Scope of Evidence

8. I have been asked by Te Rūnanga O Ngāi Tahu to give evidence about the Hinds Plains proposed Managed Aquifer Recharge (MAR) scheme.
9. My evidence addresses the proposed use of MAR as set out in the following reports:
 - (a) Managed Aquifer Recharge (MAR) as a tool for managing water quality and quantity issues. Report No. R14/80, ISBN 978-1-927314-41-8, 2014
 - (b) Hinds plains water quality modelling for the limit setting process, Report No. R13/93, ISBN 978-1-927274-37-8, 2013
 - (c) Integrated catchment modelling of the Hinds Plains Model development and scenario testing Report No. R14/64, ISBN 978-1-927314-06-7 2014
 - (d) Economic impact assessments of the Hinds water quantity and quality limit setting process, Report No. R14/82, ISBN 978-1-927314-47-0, June 2014

Figure 3: Contrasts in the water balance of a catchment, showing the effectiveness of MAR.

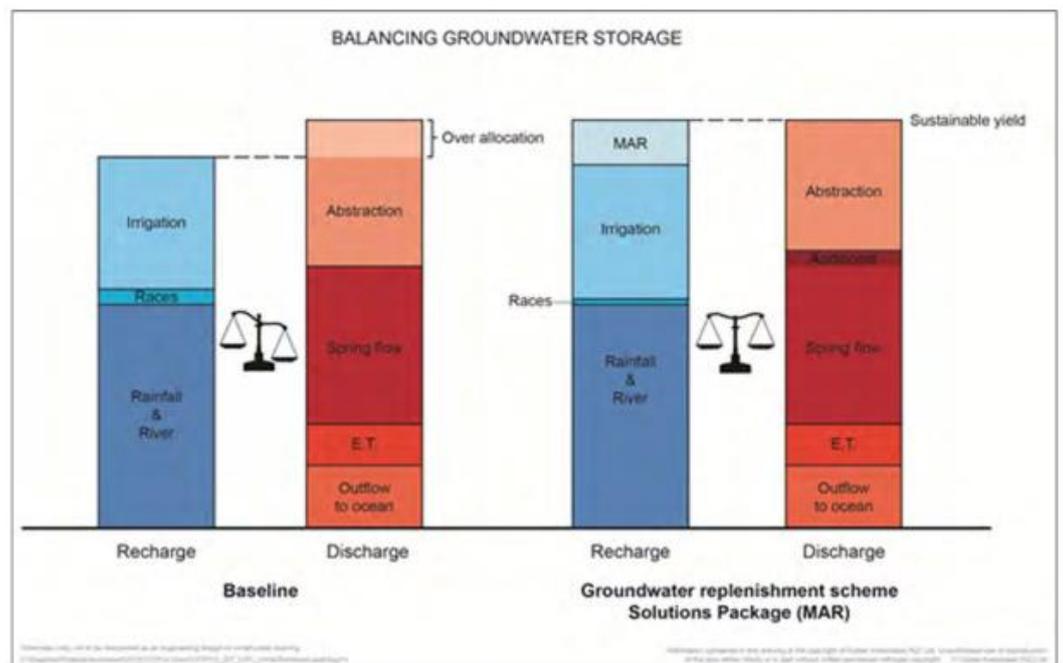
20. When recharge results in an increase in hydraulic head within the aquifer, the increase propagates down-gradient of the recharge area. Increase in hydraulic head occurs down gradient from the recharge area as a pressure response which moves faster than groundwater flow. Figure 3⁴ (below) indicates that MAR will increase spring flow as a result of increased hydraulic head in the aquifer. An increase in hydraulic head in the aquifer will also increase discharge to the ocean. Raising hydraulic head up-gradient will raise hydraulic head down gradient. Increased hydraulic head at the foot of the basin will increase flow to the ocean. This increase is not apparent in the graphical representation.
